**NEI 99-02 FAQ 14-02  
Fort Calhoun MSPI**

**Plant:** Fort Calhoun Nuclear Station

**Submittal Date:** 05/14/2014

**Performance Indicator:** MS06 Mitigating System Performance Index (Emergency AC Power Systems)

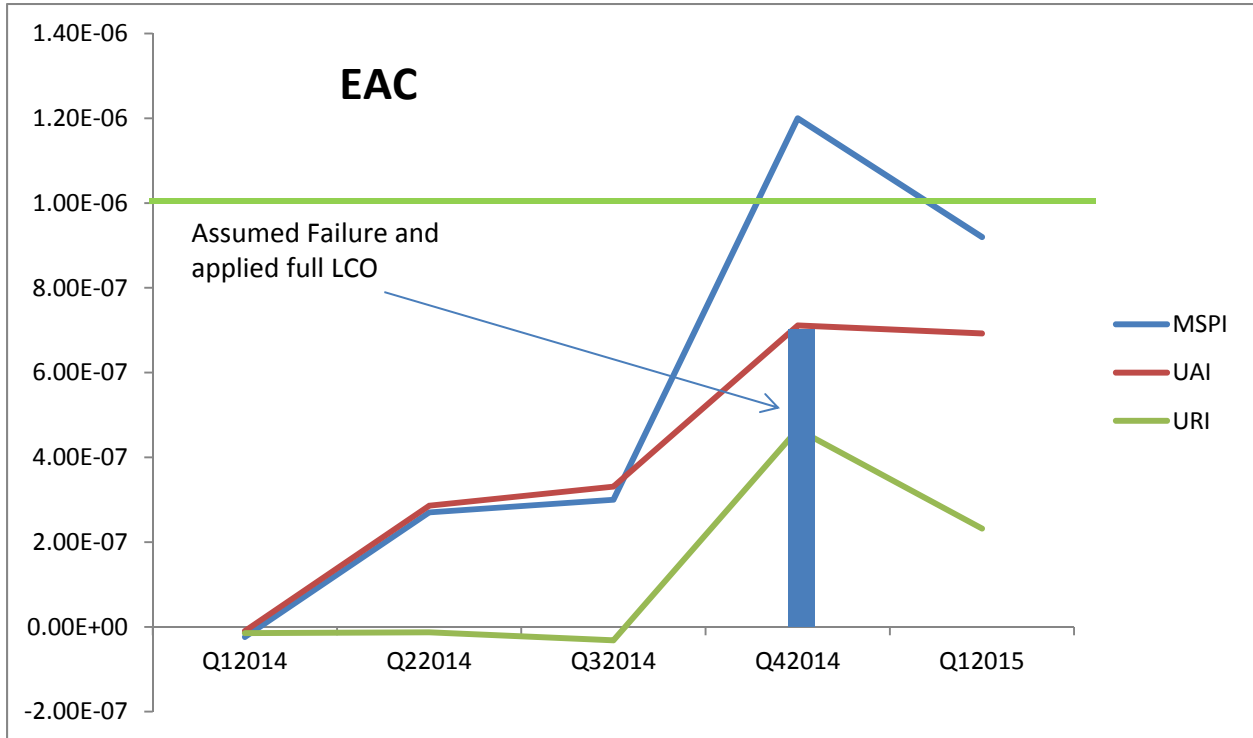
The charts below illustrates the impact for the EAC and RHR systems from having a failure and associated unavailability in the 4<sup>th</sup> quarter 2014 and the impact on MSPI as additional critical hours are accrued:

Q1 2015 MSPI decrease reflects a Feb 2012 failure dropping out of the 3 year monitoring period.

Both DG 2 Year Overhauls (103 hours each) are included in 2014 estimate.

Past MSPI values reflect original estimate for observed period.

Given that FCS restarted on December 2013, the quarter prior to startup is 3Q-2013. All MSPI values for FCS were green in 3Q-2013. Therefore, the starting point in treating the validity of the MSPI indicators is that: *MSPI will remain grayed out until there is a total of 12 months of operation in the 3-year monitoring period.* For this particular case, 4Q-2014 represents the time-frame at which a total of 12 months of operation have been accumulated.

In this FAQ, the licensee, FCS, proposes that the High Pressure Safety Injection (HPSI) system MSPI, Heat Removal System (HRS) MSPI, and Cooling Water System (CWS) MSPI become valid on the 4<sup>th</sup> quarter of 2014. However, FCS proposes that the Emergency AC (EAC) power and Residual Heat Removal (RHR) system MSPI indicators become valid on the 1<sup>st</sup> quarter of 2015 and 1<sup>st</sup> quarter of 2016, respectively.

FCS predicted future MSPI values using a Pressurized Water Reactor Owners Group “What-if” tool and expected plant data for unavailability and unreliability. These estimated MSPI values defined the licensee’s proposal of the respective effective dates for each MSPI indicator to become valid. The NRC staff agrees with the proposal for the HPSI, HRS, and CWS MSPIs to become valid on 4Q2014, and for the EAC MSPI to become valid on 1Q2015. However, the NRC staff does not agree with the proposal for the RHR MSPI to become valid on 1Q2016.

The NRC staff concludes that: (1) the HPSI, HRS, and CWS MSPIs should become valid on 4Q2014, and (2) the EAC and RHR MSPIs should become valid on 1Q2015.

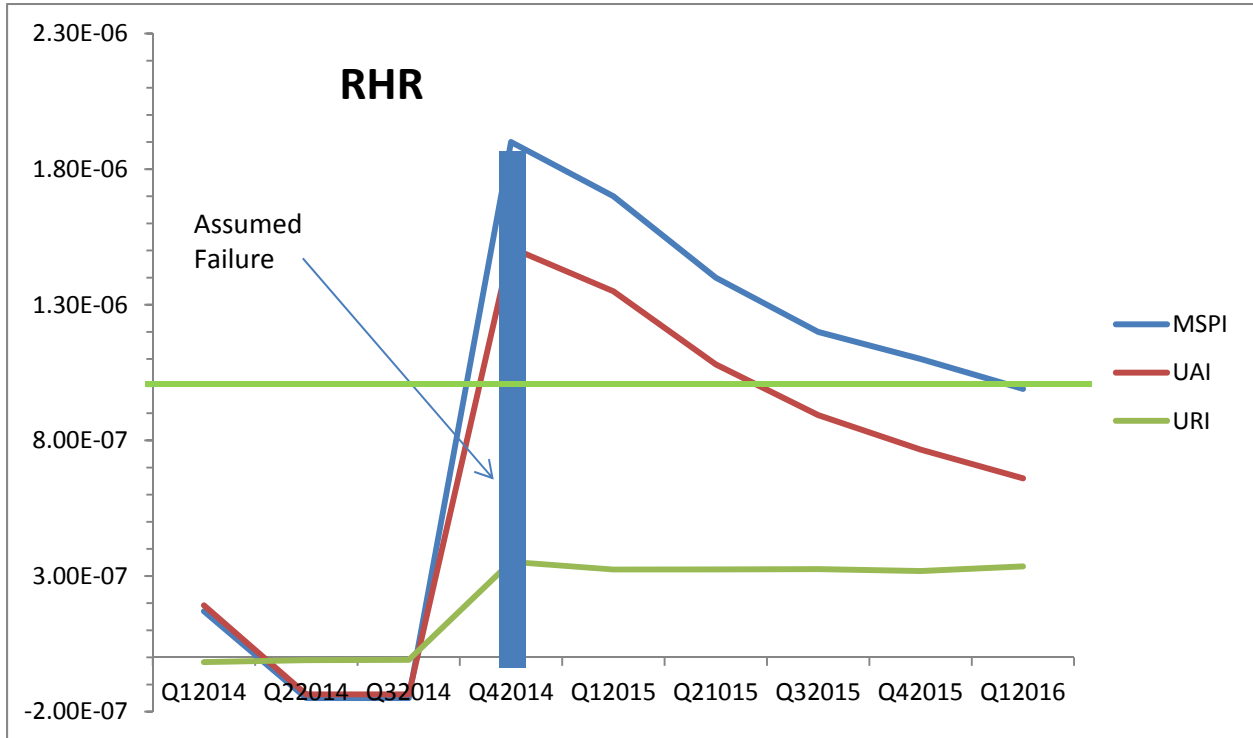
Estimated planned unavailability hours for each quarter: 7 hours.

RFO27 is scheduled for 45 days during Q2\_2015.

The staff recognizes that the approach to maintain the RHR MSPI indicator invalid before 9 quarters of operational data have been accrued proactively prevents the indicator from resulting in a false positive due to accrued unplanned unavailability. However, various factors such as increase in inspection resources, aggregation of various inputs to the indicator, alignment with previously established positions, and external stakeholder communications should also be taken into consideration when defining an effective date for the indicator to become valid.

- Having the RHR MSPI invalid before 9 quarters of data have been accrued will increase inspection resources. While a baseline inspection approach would be applied to all other systems covered by MSPIs, additional inspection hours would have to be implemented to gain performance insights on the RHR system.

- Having the RHR MSPI invalid before 9 quarters of data have been accrued limits the indicator from providing insights on RHR performance based on the estimated outcome of accrued unplanned unavailability. It does not allow the indicator to provide insights on RHR performance that might result from any other failures and/or unavailability observed under this indicator.

- The approach of having the RHR MSPI invalid before 9 quarters of data have been accrued results in a significantly different treatment from that used for the other MSPIs. It also diverges noticeably from the starting point for evaluation of such situation that was discussed through white papers in the ROP WG (ADAMS Accession No. ML13079A728), and the initial characterization of this FAQ. Such divergent approach can impact the overarching ROP goals of understandability and predictability.

- Having the RHR MSPI invalid before 9 quarters of data have been accrued while all other MSPI indicators are treated as valid performance indicators can present communication challenges to external stakeholders. Such unique approach would impact the clarity of the performance indicator program.

Since historical data on RHR unplanned unavailability was not considered, accounting for the Technical Specifications (TS) Allowed Outage Time (AOT) (i.e., 7 days) could be a highly conservative estimate. If an indicator is really “invalid” for 9 of a total of 12 quarters (75%), what other types of implications can be inferred? Although TS SSCs in general make-up the list of monitored components in MSPI, the AOTs, surveillance frequencies, etc. do not necessarily correlate with risk importance (i.e., maybe TS AOTs is not a good input to use for a risk-based calculation).
